Proposed Sustainable Energy Plant at Brunner Mond, Lostock, Northwich, Cheshire

Supplementary Environmental Information

Addendum to Environmental Statement

September 2010

Figure 1

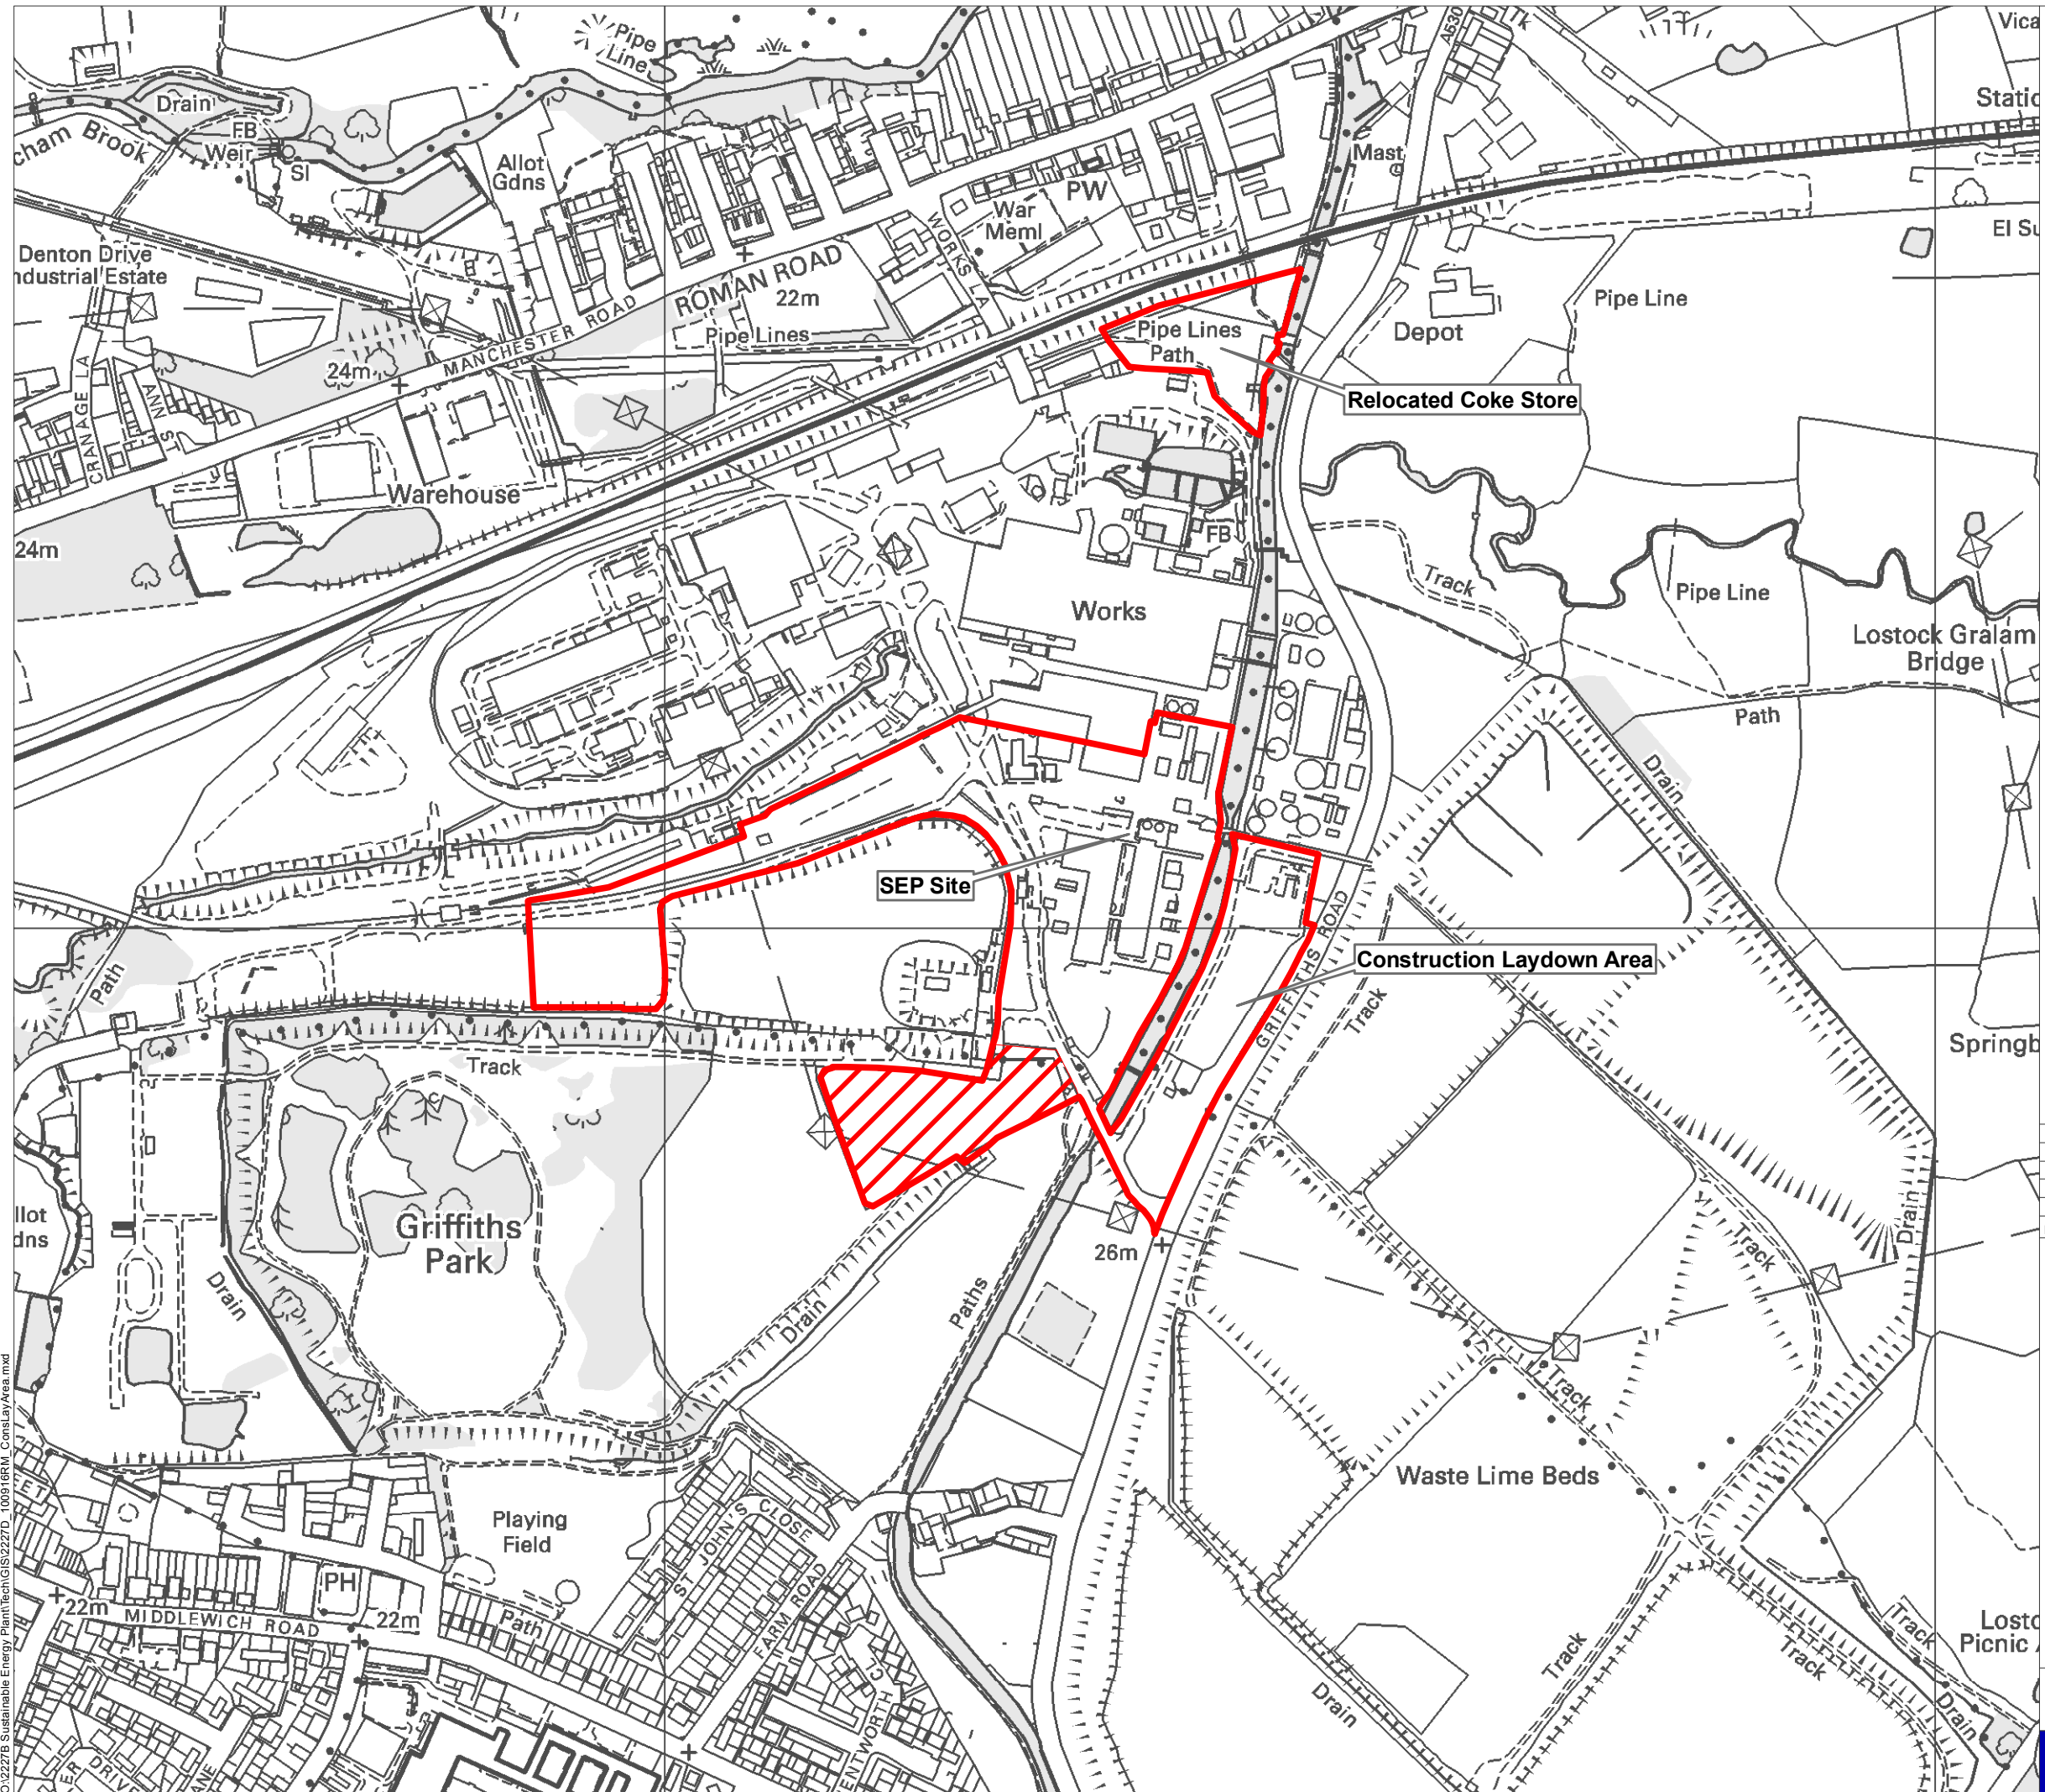
- An addition to the existing red line application boundary to accommodate an additional or alternative construction lay-down area (Figures P/5002 Rev-)

- The new red line application boundary, the area of which has increased from 9.2 ha to 10.57 ha (see Figure 1 of this report)
- A new set of application drawings, that now use a new numbering system referred to as the '5000' number series. Unlike the original set where the last number in the figure reference started with '0', the new drawings will begin with the number '5' in order to distinguish them from the original set (even where no physical change to the drawing occurs). In addition the original revision references to the plans have been cleared; one will now only see 'Rev-' on the new set of drawings.

- 3.2 “The application site, as shown in Figure P/5002 Rev-, occupies an area of approximately 10.57 ha. This includes the following components:
- Main SEP site, including Ash Handling Facility and Rail Reception Facility: 6.4ha;
 - Construction laydown areas: 3.27ha;
 - Relocated coke store: 0.9ha.”

8.3 An alternative or additional area of land is proposed south west of the main site area to accommodate an alternative construction laydown area. This area is approximately 1.37 ha of existing redundant land.
